**Further Information -Planning Application No. A/YL-KTS/1108
refers) Section 16 Planning Application for Proposed Temporary
Warehouse (excluding Dangerous Goods Godown) with Ancillary
Facilities and Associated Filling of Land for a Period of 3 Years at
Lot Nos. 1229 (Part) and 1367 RP in DD 106, Kam Tin, Yuen Long,
New Territories.**

Drainage Proposal

Responses to DSD's Comments on 20 February 2026

Figure A – Location of Photos

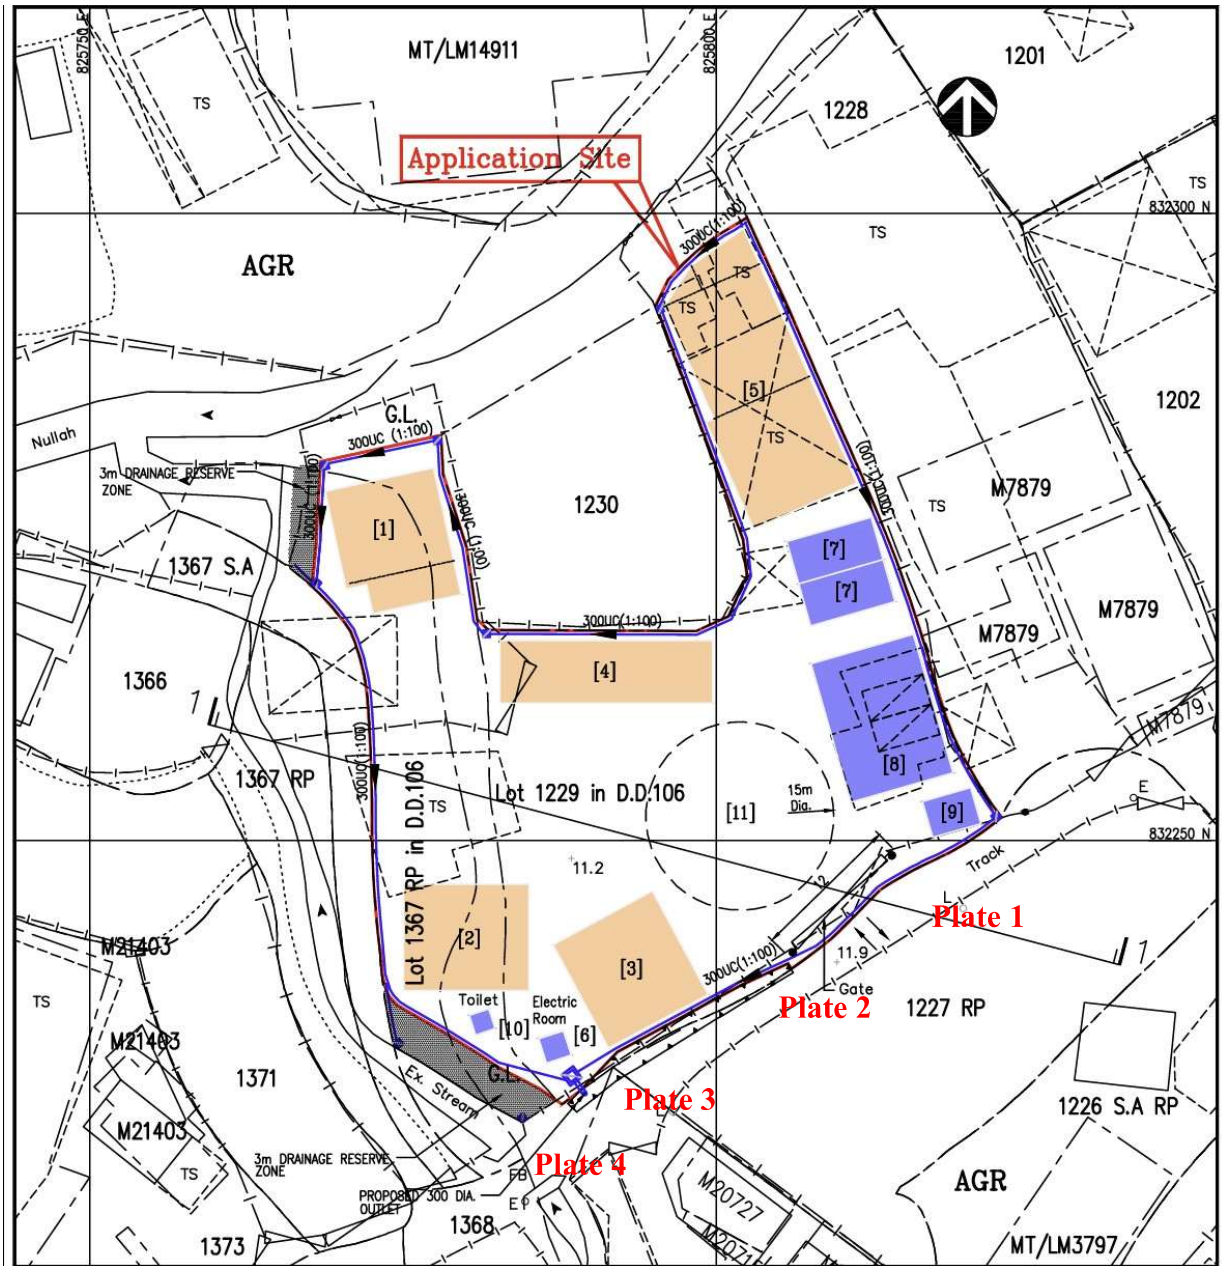
<p>(ix) Further to (viii) above, since there is no record of the said discharge path, please provide site photos to demonstrate its presence and existing condition. Please also indicate the size of the existing channel on the drainage plan for review. The applicant should check and ensure the hydraulic capacity of the existing drainage facilities would not be adversely affected by the captioned development.</p>	<p>The site photos are given in the report. The existing stream is immediately at the western side of the site.</p>

Figure:
 D-03
Scale:
 N.T.S.
Date:
 April 2026

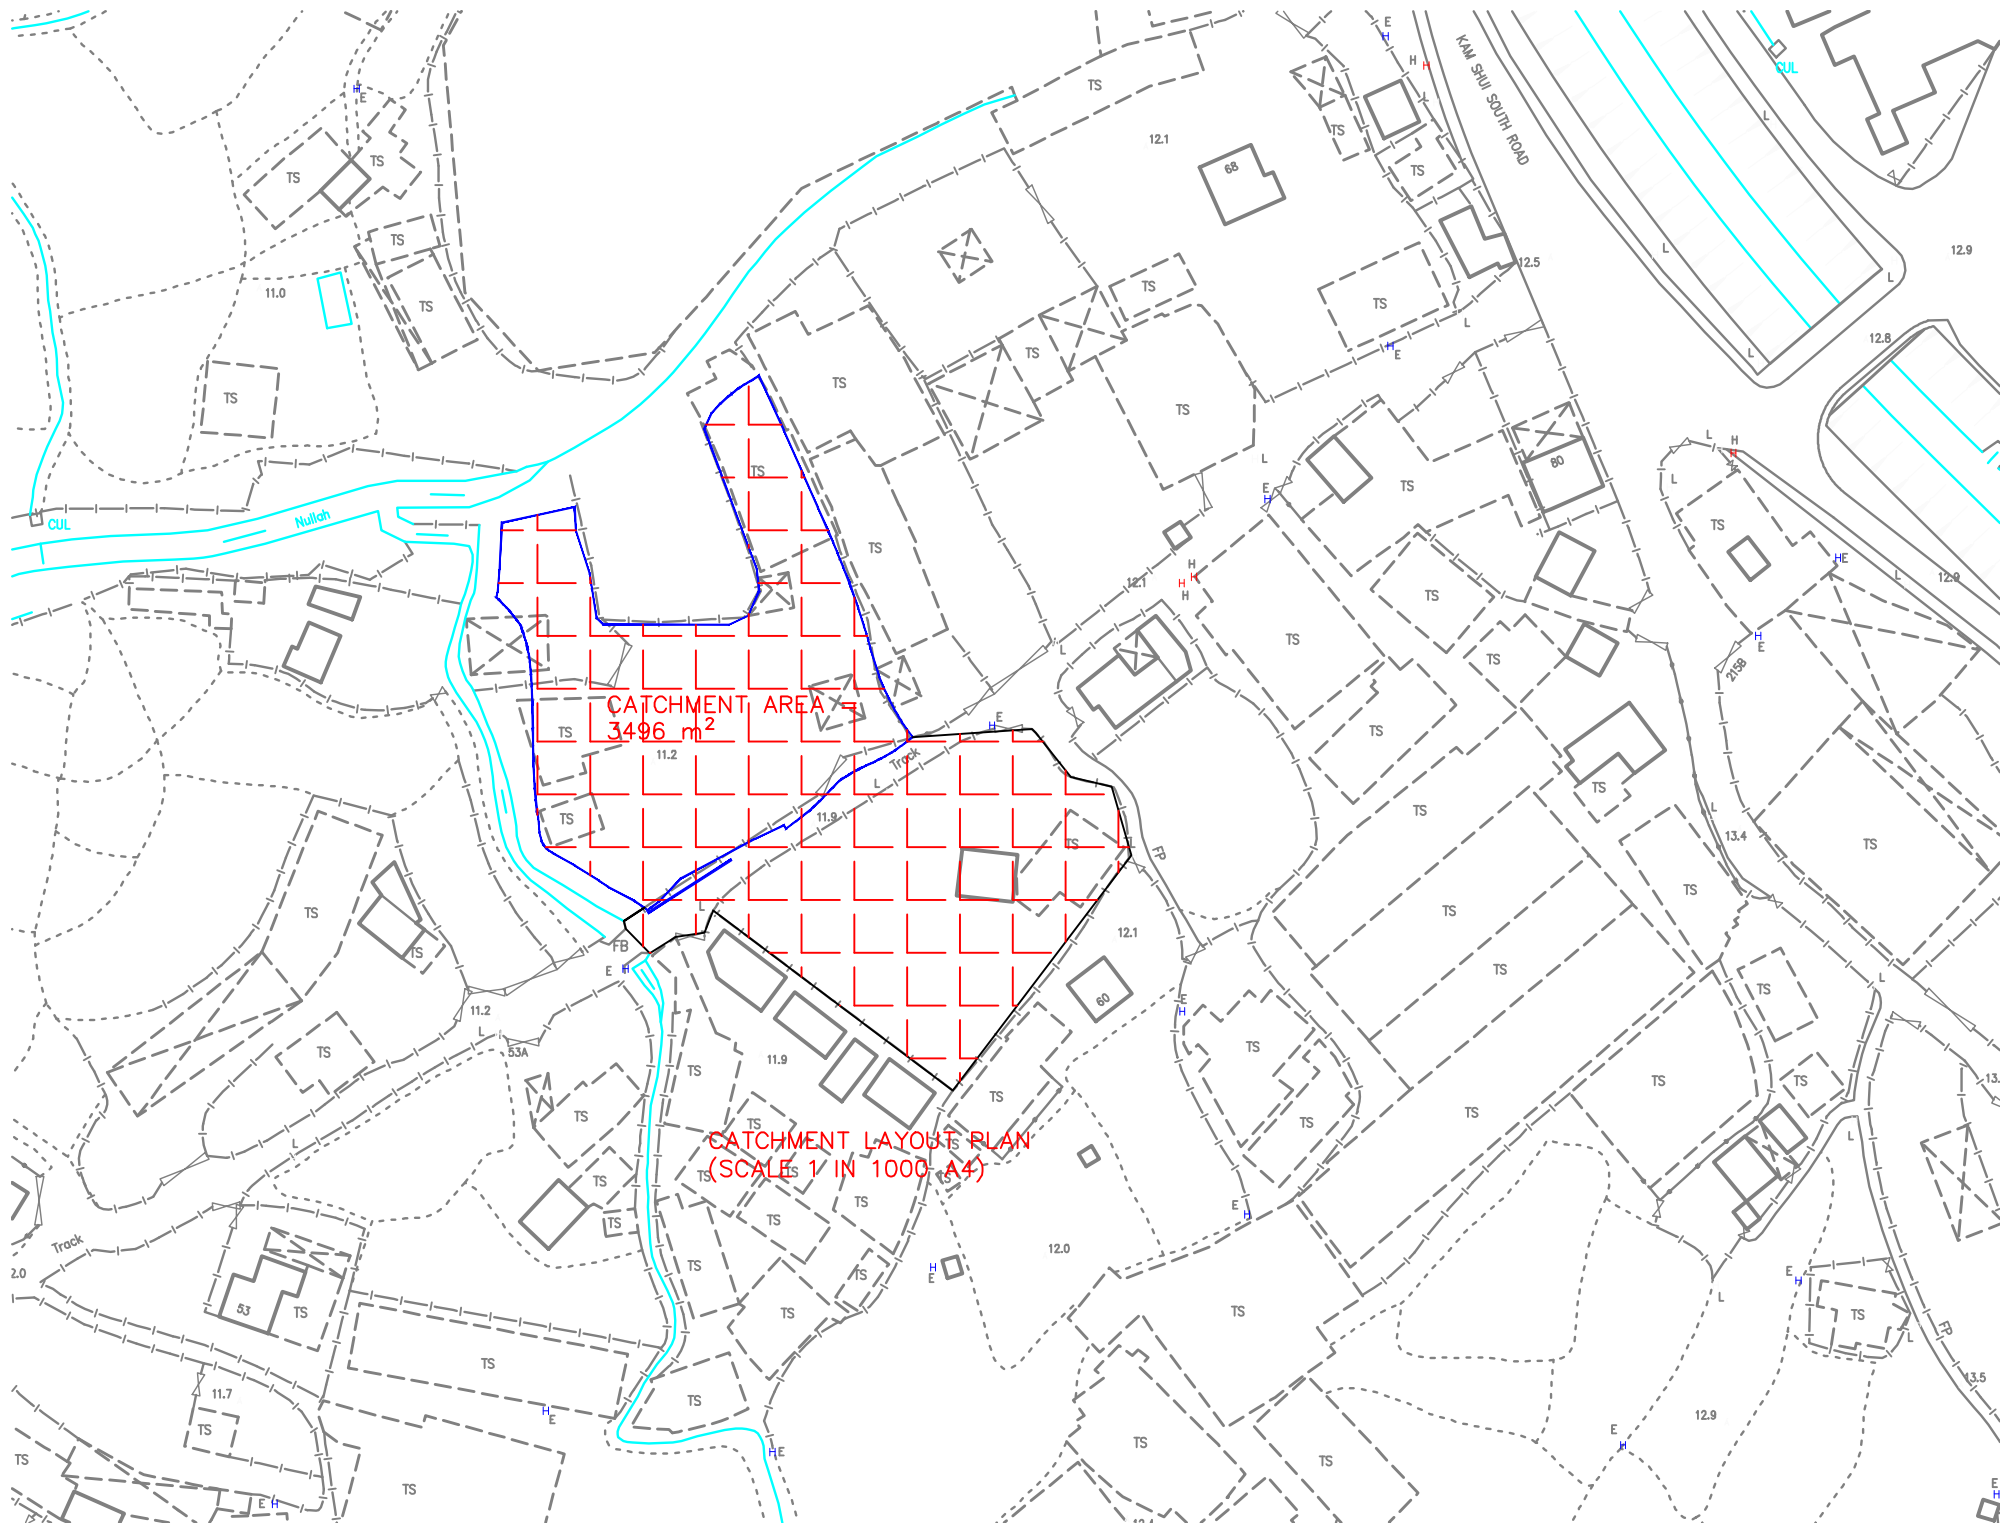
<p>(vi) Please advise if any site formation/levelling works to be carried out under this application. Cross sections showing the existing and proposed ground levels of the captioned site with respect to the adjacent areas should be given.</p>	<p>Cross section SECTION 1-1 is produced. The land is sloping 1 in 200 after filling to +11.3mPD to +11.2mPD respectively.</p>
<p>(vii) Please confirm if any walls or hoarding are/to be erected or laid along the site boundary. If affirmative, adequate opening should be provided to intercept the existing overland flow passing through the site and please provide its details for comments.</p>	<p>Opening of 300mm wide is to be provided at 2m c/c at the hoarding toe.</p>
<p>(viii) According to Figure D-01, the existing channel, to which the applicant proposed to discharge the stormwater from the subject site was not maintained by this office. The applicant(s) shall resolve any conflict/disagreement arisen for discharging the runoff from the applicant site(s) to the proposed discharge point(s). In the case that it is a local village drains, DO/YL should be consulted. Moreover, the applicant(s) should ensure that this drainage system and the existing downstream drains/channels/streams have adequate capacity to convey the additional runoff from the application site(s). Regular maintenance should be carried out by the applicant(s) to avoid blockage of the system.</p>	<p>Noted and agreed.</p>

<p>(x) Please provide the connection details to the existing channel for comment.</p>	<p>The connection details is given in Figure D-03 in Appendix A. It is a 300mm dia. Downpipe.</p>
<p>(xi) Please indicate clearly the full alignment of the discharge path from the application site all the way down to the ultimate discharge point (e.g. a well-established stream course/public drainage system).</p>	<p>The existing stream course is located immediately to the west and north of the application site.</p>
<p>(xii) Catchpit should be provided at the turning point of the proposed u-channel.</p>	<p>Noted and used.</p>
<p>(xiii) Please clearly indicate the flow direction of the proposed drainage facilities on the drainage plan for review.</p>	<p>Noted and given.</p>
<p>(xiv) The development should neither obstruct overland flow and nor adversely affect existing natural streams, village drains, ditches and the adjacent areas, etc.</p>	<p>Noted and catered.</p>

CATCHMENT LAYOUT PLAN
(SCALE 1 IN 1000 A4)

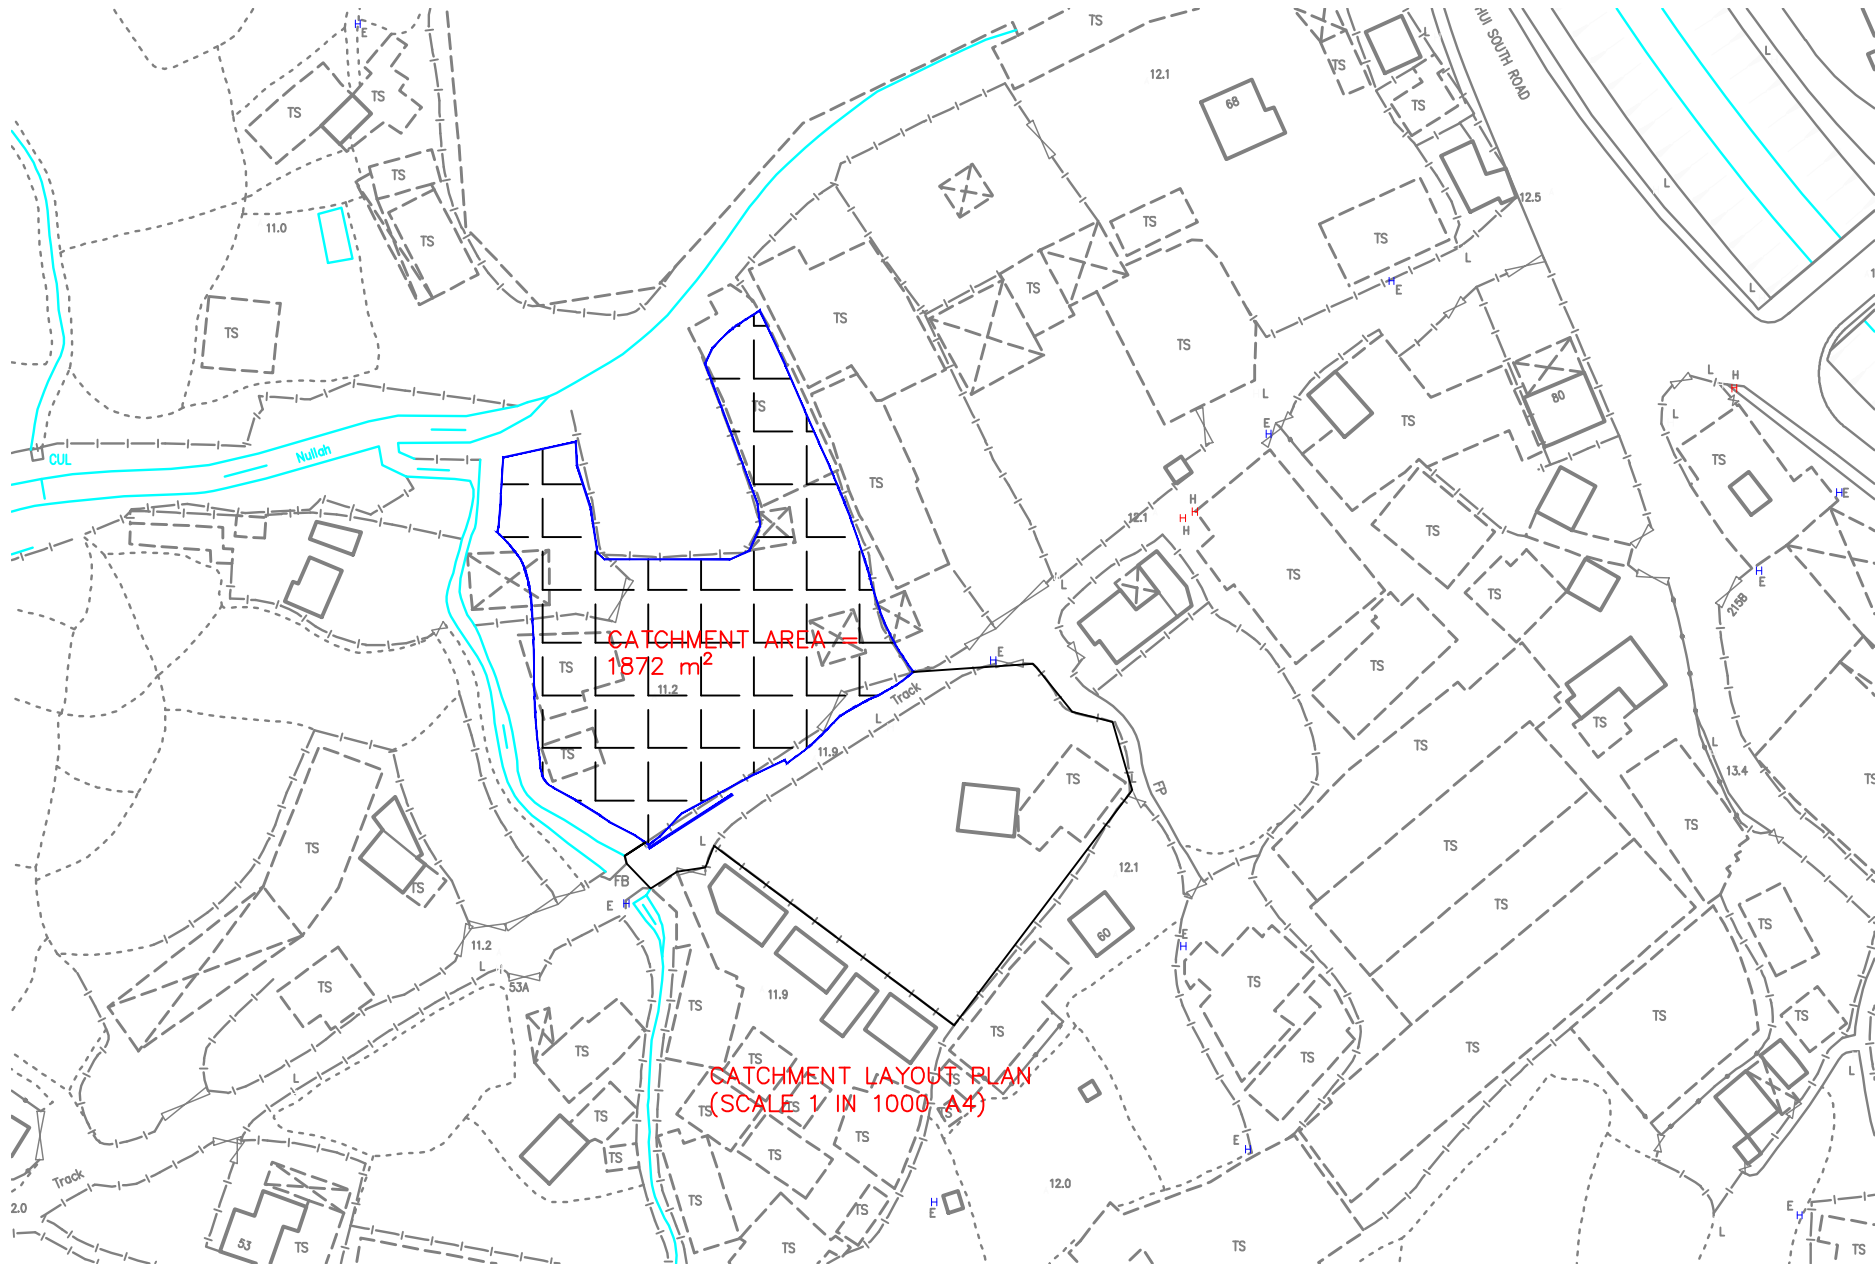
<p>(iv) The ground to the east and south of the application site is generally higher. Since the overland flow from the adjacent lands shall be probably intercepted, external catchment shall be considered in the calculation.</p>	<p>Extra catchment from the southern side is considered in the checking.</p>
<p>(v) The gradient of the proposed U-channels/pipes should be shown on the drainage plan.</p>	<p>Indicated. All 1 in 100.</p>
